State of New Mexico
Energy, Minerals and Natural Resources

WELL API NO. 30-015-25141
5. Indicate Type of Lease STATE <input type="checkbox"/> FEE <input checked="" type="checkbox"/>
6. State Oil & Gas Lease No.
7. Lease Name or Unit Agreement Name Belco State
8. Well Number #1 SWD
9. OGRID Number 246368
10. Pool name or Wildcat Delaware Brushy Canyon

SUNDRY NOTICES AND REPORTS ON WELLS
(DO NOT USE THIS FORM FOR PROPOSALS TO DRILL OR TO DEEPEN OR PLUG BACK TO A
DIFFERENT RESERVOIR. USE "APPLICATION FOR PERMIT" (FORM C-101) FOR SUCH
PROPOSALS.)

Basic Energy Services L.P.
Beleo #1 SWD
Unit E, Sec 20, T23S, R28E Eddy County
API #: 30-015-25141

Basic Energy Services L.P.
Belco # 1 SWD
Unit E, Sec 20, T23S, R28E, Eddy County
APL #: 30-015-25141

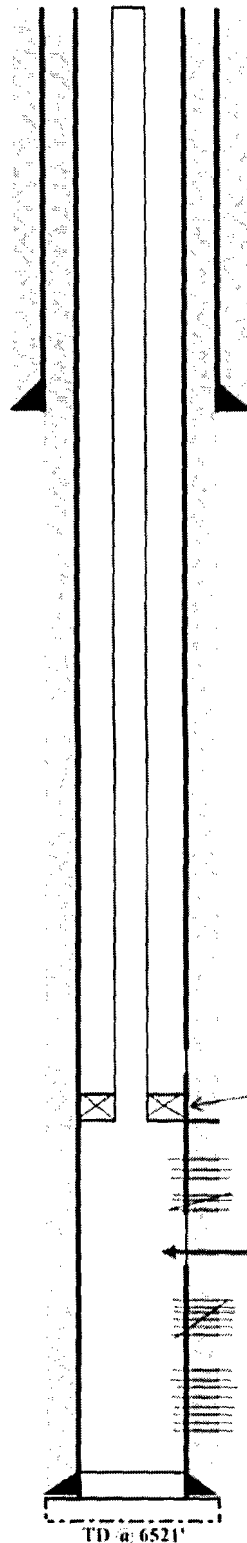
*PERF @ 523'
SQ - WOC & TAG*

Spot 25sx cmt @ ~~2100'~~ *2389'* - Tag

2389 - 2389 - COVERS DELAWARE
